Western Digital Corporation  
 5863 Rue Ferrari  
 San Jose, CA, 95138

To: T10 SAS Protocol Working Group  
 Contact: Mark Evans  
 Phone: 408.363.5257  
 Email: mark.evans@wdc.com  
 Date: ~~28 April~~ 18 September 2008

Subject: SAS-2.1 / SPL, Low power transceiver options, phy ~~and link~~ states

Figure a — PM (phy layer) state machine - SAS phy power management states

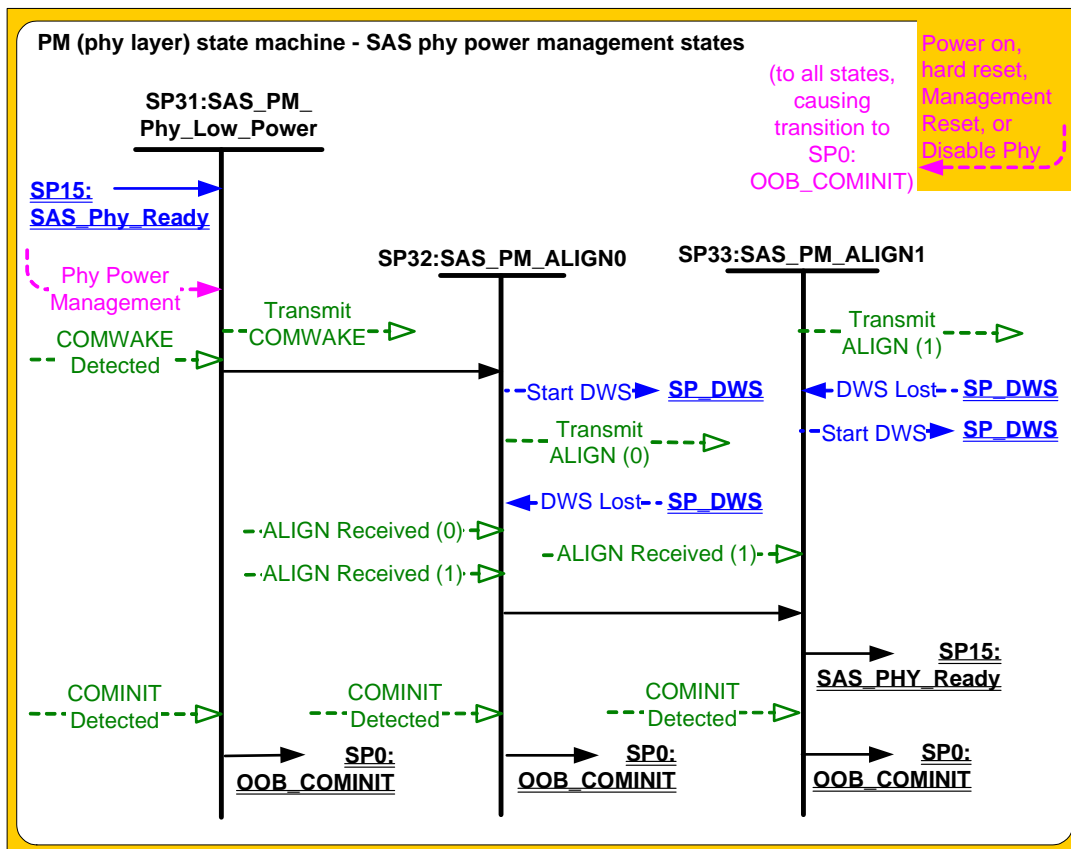
[Editor's note: this is a new clause with a new figure.]

Figure a shows the SAS phy power management states. These states are entered when a phy enters a low power condition (i.e., the SAS partial low power condition or the SAS slumber low power condition) and process the actions that return a phy from a low power condition to participating in an operational logical link.

These states are indicated by state names with a prefix of SAS PM.
